Delta Electricity

Proposed Gas Power Facility at Bamarang Stage Two Submissions Report

August 2008

Figure 1 Bamarang Layout and Waterways

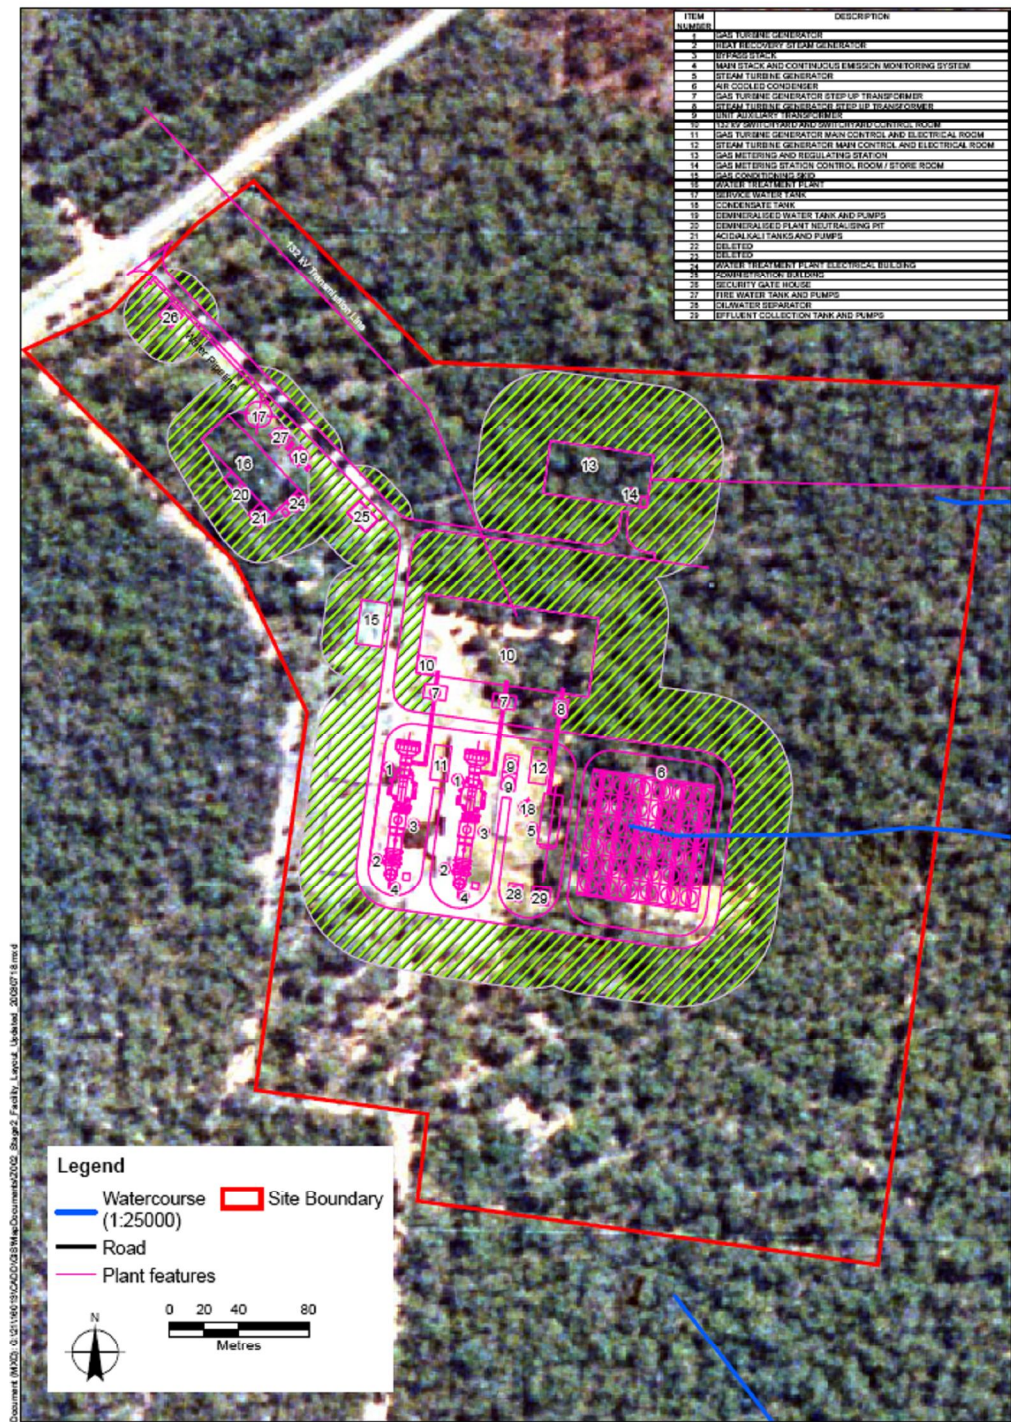
Measures for the control of stormwater have not been outlined in any detail. This needed to address how the adjoining lands (in particular the nature reserve and water catchment area) are to be protected from any pollution and runoff during the construction and operation of the plant.

Figure 1 shows the location of the waterways (as identified by the 1:25,000 topographic map) on the subject site. The proposed air cooled condenser impacts on approximately 80 metres of the top of one of these waterways.

The impacts of the location of the air cooled condenser on vegetation were addressed in the environmental assessment. As detailed in the statement of commitments, all activities at the premises would be undertaken in a manner that does not cause or permit water pollution as defined in the *Protection of the Environment Operations Act 1997*.
